UNITED STATES PATENT AND TRADEMARK OFFICE

10/733,515

Office Action Summary	Application No. 10/733,515	Applicant(s) LEE, CHOONG-JAE	
	Examiner PHYLESHA DABNEY	Art Unit 2614

DETAILED ACTION

FIG.6

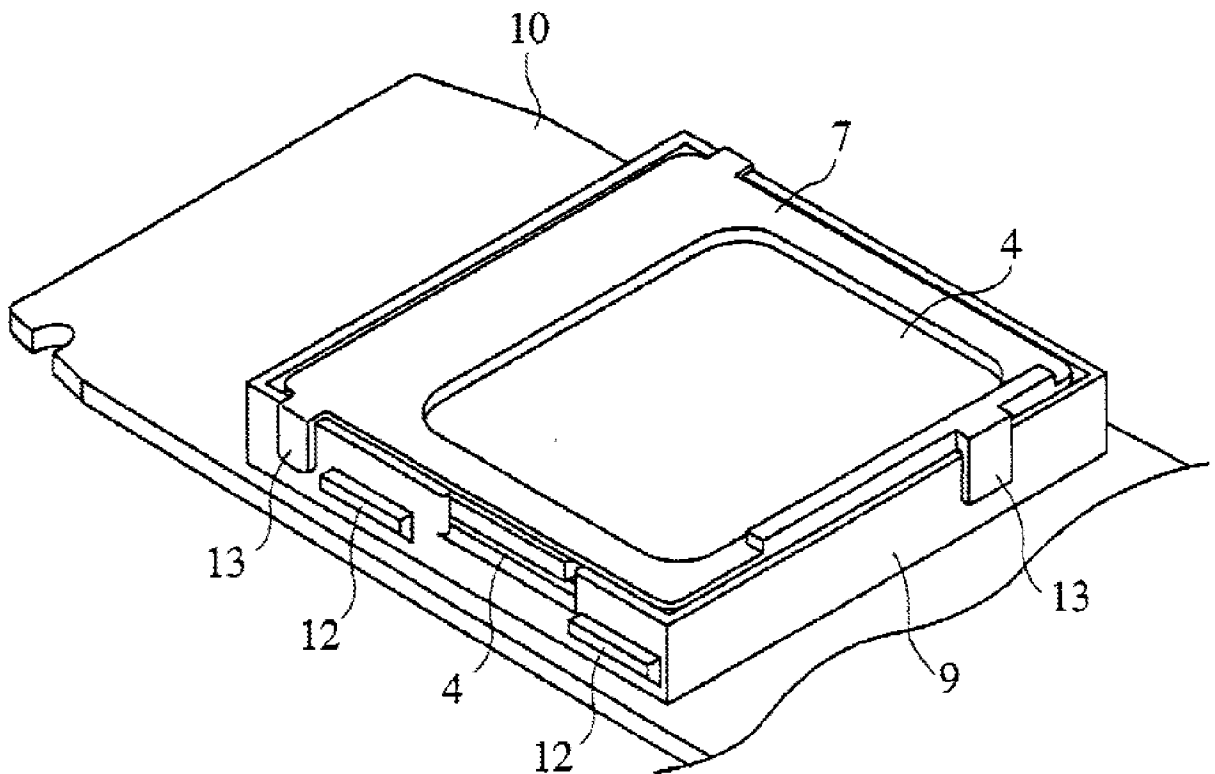
With respect to the Applicant's arguments that "*a predetermined air gap is not formed between an upper surface of the supporting rib and a lower surface of the first cover,*" the Examiner disagrees. As shown in the Figure 6 below, the claws (13) of rubber sheet (7) provides a thickness above the rib (9) such that an air gap is formed therebetween the upper surface of the rib and the lower surface of the first cover. \

Therefore, the rejection is maintained.
